Access Compliance Report

Public Rights-of-Way

(Curb Ramps)

Intersection ID: 43511	Main Street: MULBERRY_POND_DR	Cross Street: BLUEBERRY_HOLLOW_PL	Location: E
ADA ID: AB7D8F1999C1	Ramp Type: PerpDiag	Initial Pass/Fail: Fail	Overall Compliance: No
Severity Score: 25			
Codes/Mitigation Info/Possible Solution		Field Measurements/Component Compliance

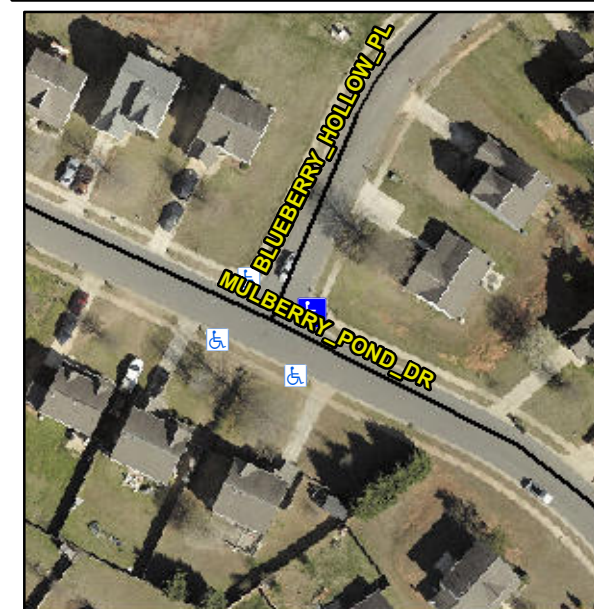
Not Found, R304.5.3

Compliance	Description	Data	Compliance	Description	Data
N/A	Ramp Length (in)	48.0	Yes	Ramp Slope (%)	7.3
Yes	Ramp Width (in)	48.0	No	Ramp XSlope (%)	10.1
N/A	Flare Type LT	N/A	N/A	Flare Type RT	N/A
N/A	Flare Slope LT (%)	N/A	N/A	Flare Slope RT (%)	N/A
N/A	Flare Traversable LT?	N/A	N/A	Flare Traversable RT?	N/A
N/A	Landing Length (in)	N/A	N/A	DWS Provided?	N/A
N/A	Landing Width (in)	N/A	N/A	DWS Contrast?	N/A
N/A	Landing Slope (%)	N/A	N/A	DWS Length (in)	N/A
N/A	Landing X Slope (%)	N/A	N/A	DWS Full Width?	N/A
N/A	Landing Curb? (Y/N)	N/A	N/A	DWS Offset (in)	N/A
N/A	Shared Landing?	N/A			
N/A	Gutter Ponding?	N/A	N/A	Gutter Slope (%)	N/A
N/A	Gutter Lip Ht (in)	0.5	N/A	Gutter X Slope (%)	N/A
N/A	Painted X Walk1?	No	N/A	Painted X Walk2?	No
	X Walk 1 Direction	To NW		X Walk 2 Direction	To SW
N/A	X Walk 1 Width (in)	N/A	N/A	X Walk 2 Width (in)	N/A
	X Walk 1 Slope (%)	2.3		X Walk 2 Slope (%)	5.4
	X Walk 1 X Slope (%)	5.6		X Walk 2 X Slope (%)	5.3

Remove & Replace Curb Ramp With Two New Directional Ramps or Equivalent.
